Front Upper Strut Mount

Ride Control, LLC has identified a defect that may affect the operation or safety of your vehicle. This defect may exist in four Gabriel branded strut mount part numbers. Therefore, Ride Control, LLC is recalling the affected part numbers as described below. This notice is issued in accordance with National Highway and Transportation Safety Administration requirements.

# a. STRUT MOUNT NOT AFFECTED BY RECALL

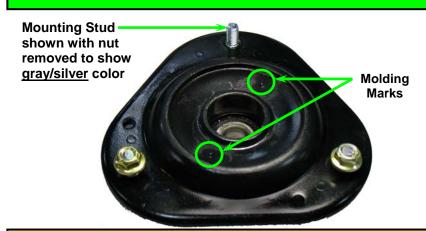
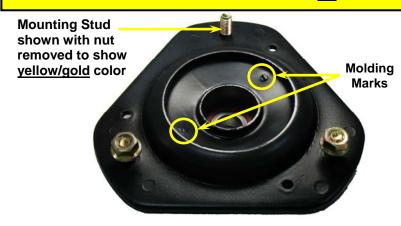
- 1) The rubber portion of the mount has two marks that can be seen from the top of the mount.
  - a. Good Part Marks are raised and are approximately 3/32"(2.2mm) in diameter.
  - b. Recalled Part Marks are flat in shape and range in diameter from 3/16"(4.6mm) to 9/32" (7.0mm).
- 2) The mounting studs have unique coloring. They will be either (gray / silver) or (yellow / gold)
  - a. Good Part Mounting studs are gray/silver in color.
  - b. Recalled Part Mounting studs are yellow/gold in color.

# **b. STRUT MOUNT IS AFFECTED BY RECALL**

Please contact Gabriel Technical Services toll free at 1-800-999-3903 to receive instructions for reimbursement and replacement with Gabriel brand parts. We request all impacted consumers to maintain possession of your recalled strut mounts and store receipts until you have contacted Gabriel Technical Service personnel and obtained disposition instructions. Thank You.
